# Access Compliance Report

## Public Rights-of-Way

Intersection ID: 21411	Main Street: MONROE_RD	Cross Street: SARDIS_RD_NORTH	Location: NE
ADA ID: EE89D08B30CE	Ramp Type: BlendTrans1	Initial Pass/Fail: Pass	Overall Compliance: No
Severity Score: 2.75			
Codes/Mitigation Info/Possible Solution		Field Measurements/Component Compliance

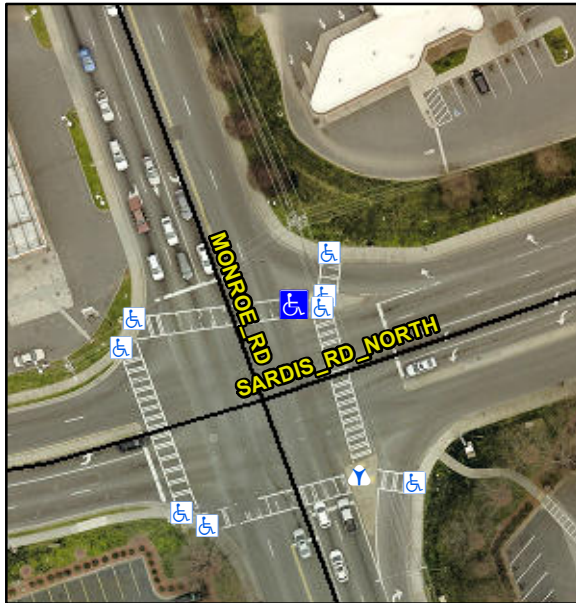
**Remove & Replace Curb Ramp With Two New Directional Ramps or Equivalent. Gutter Ponding Observed.**

**LOCATED ON MEDIAN**

**R304.5.3, R304.2.2-Perp, R304.3.2-Para, R305.1.4, R305.2, R302.7**
